AWC DATABASE CATALOG/ATLAS
CORRECTION FORM

Map: Icy Bay D-2 & D-3, D-2 & D-3 N, Inset, Icy Bay 1:250

Water Body Number: 186-15-10550-2005-3002-4019

Nomination Number: 14-658

Figure 1.-186-15-10550-2005-3040 tributary 3 addition map.

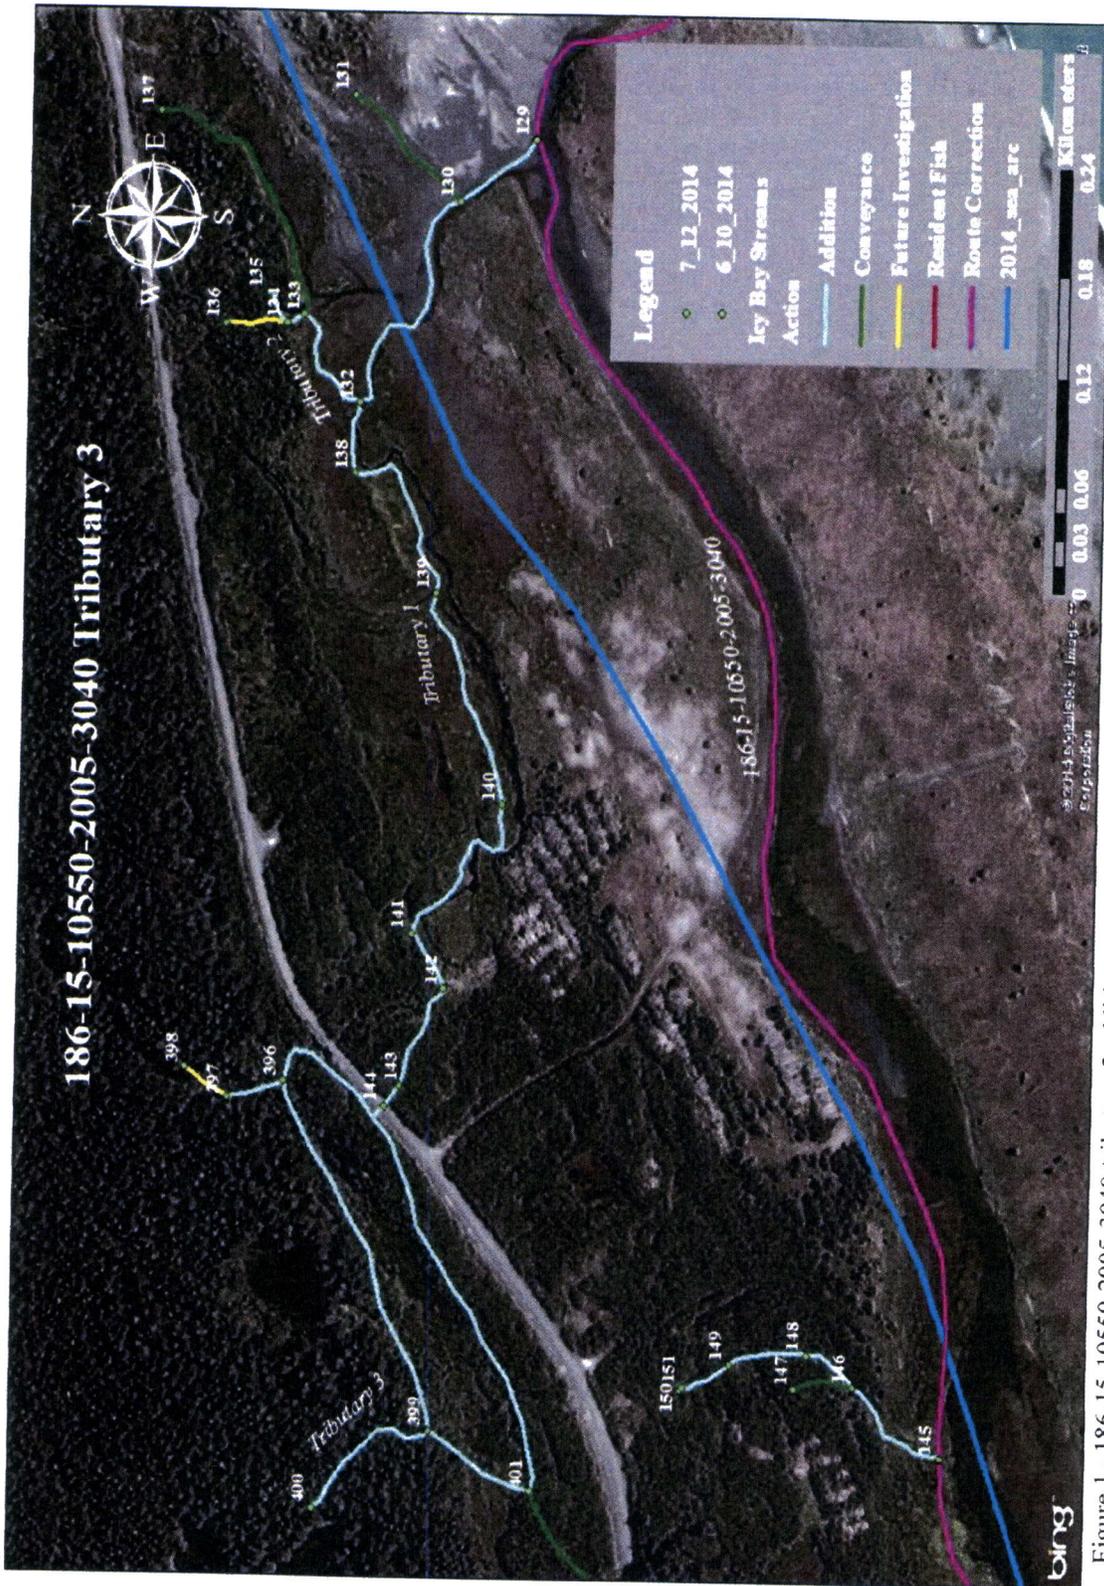
Findings: We surveyed a tributary to stream 186-15-10550-2005-3040 using a GPS and handnet. We were able to catch rearing coho salmon. This stream ends at the base of a 5 foot tall beaver dam. The dam is a fish barrier since stream is so small and no pools for fish to use to get around.

Recommendations: Add stream to AWC and add rearing coho.

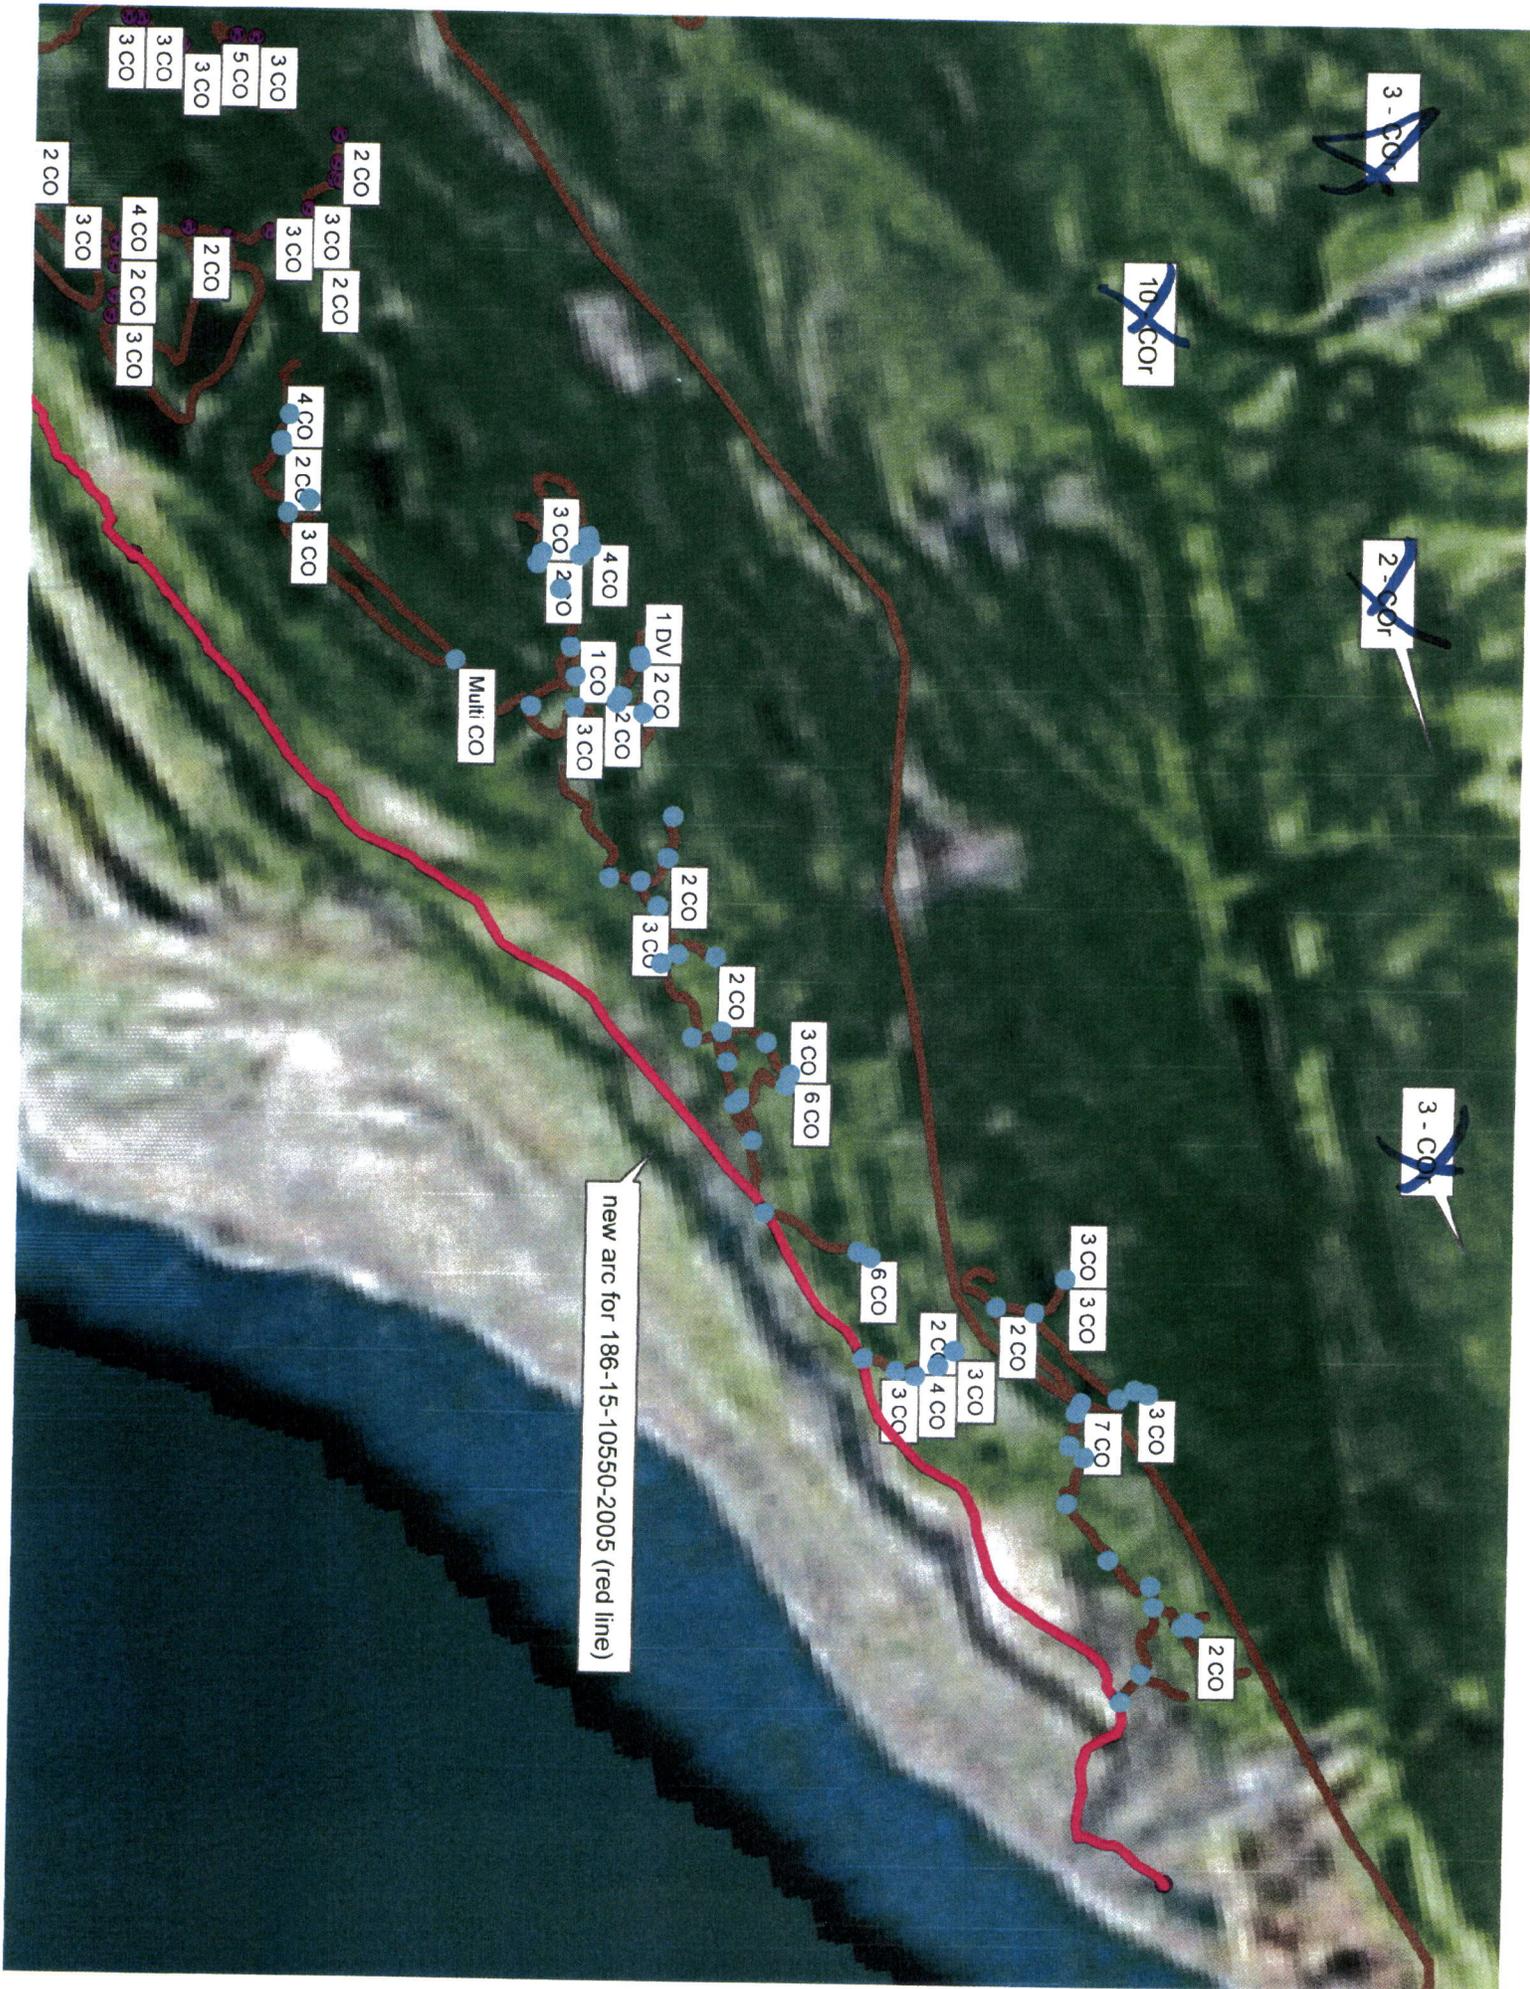
add new streams 186-15-10550-2005-3002-4015 & -4019
w/coho salmon rearing
use FIDS 77, 78 from hoffmanicybaylcy Bay stream layerlcy Bay.shp for hydro
